Service information

Reference no.: SDA_111962

MANDATORY CHECK: verify the correct position of the Air stop in all repairs for Incanto and Gaggia Anima machines

Image1

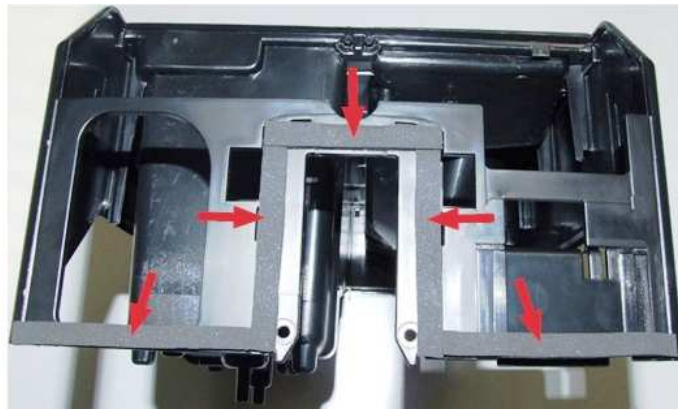
Up to SN: TW901550690343 the machines were assembled with five pieces of 'Air stop*', to prevent humidity going into the machine. It could happen that the position of the 'Air stop' is not ok (gaps between separate pieces) and humidity can pass through. This can cause display malfunctioning or short-circuit on the CPU board, which in turn generate other defects such as switching thermostats.

1. Check the correct positioning of the air stop at each machine (Up to s.n. TW901550690343). Correct positioning without gaps between the single pieces is shown in below (Image1).
2. If there should be gaps between parts of the 'Air stop' or if it should be damaged / missing, replace it by cod. 421944063091 WHT ADH.AERSTOP UPP.CAS.COV.SMRG (Image2)

From s.n. TW901550690344 inserted the cod. 421944063091 WHT ADH.AERSTOP UPP.CAS.COV.SMRG
